RE: PLANNING SUBMISSION IN RELATION TO THE STATE SIGNIFICANT DEVELOPMENT APPLICATION – SSD-11606719

PROPERTY AT: 1 KANGAROO AVENUE, EASTERN CREEK (LOTS 1-2 DP 1145808, LOT 2 DP 1247691, LOT 7 DP 1200048)

Figure 3 Assessment locations (Source: SSD-11606719 Environmental Impact Statement)

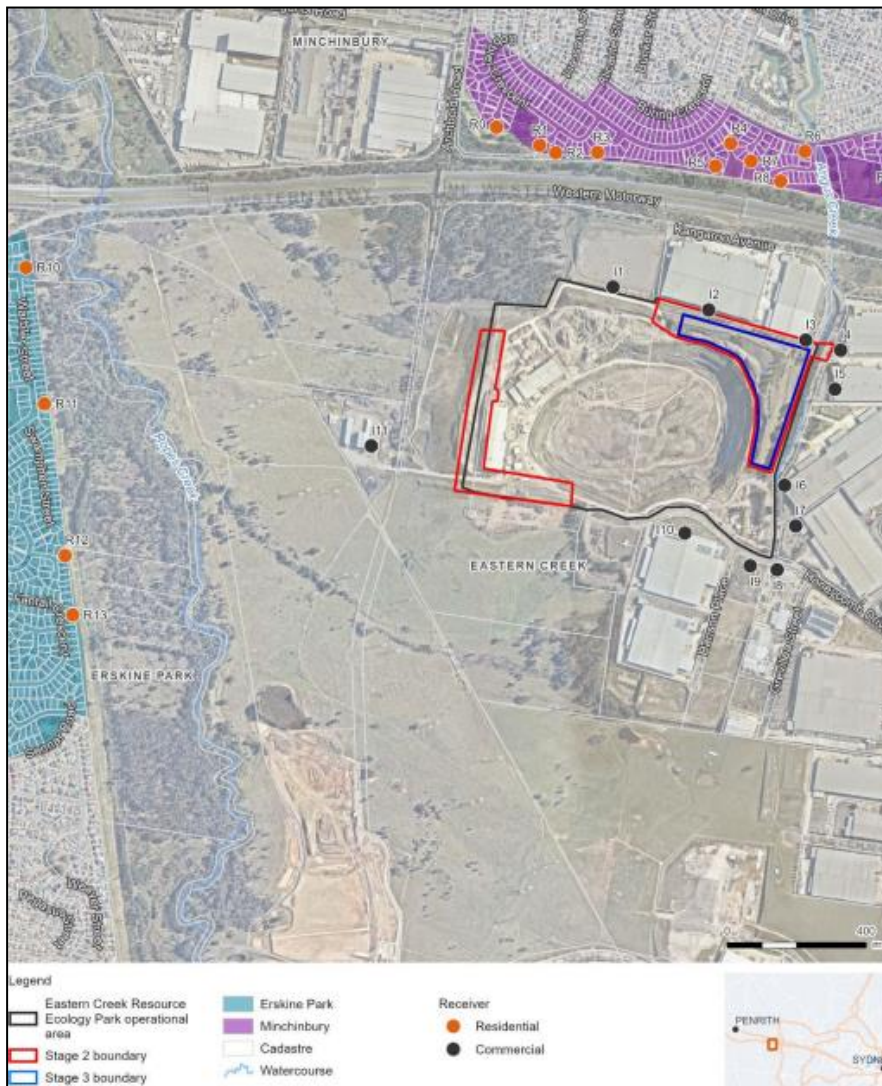
The *SSD-11606719 Environmental Impact Statement* prepared by Arcadis Australia Pacific Pty Limited (Arcadis) for the Proposal has been reviewed and outlines that the Site is in close proximity of sensitive residential receivers to the north of the Site (refer to **Figure 3**).

This objection has been made against the Proposal based on the observations and information provided in the *Noise and Vibration Impact Assessment Report*. There is potential that there will be impact of noise on the adjoining land owned by the Objector due to the proposed works as:

- The noise associated with the intensification of the use of the Site will impact on the acoustic amenity of the workers in the existing warehouses/industrial facilities on the Frasers owned land,

- It is unclear whether the road traffic noise analysis considers the proposal in its respective stages. This should be clarified in the NVIA.
- It is noted that the approved hours of operation of the REP involves 24 hours operation for particular operations at the Site. Truck deliveries to the Site are approved from 5:00am to 9:00pm. The approved hours of operation should be reviewed, considering the potential traffic noise impacts associated with the Proposal for an intensification of operations at the site.
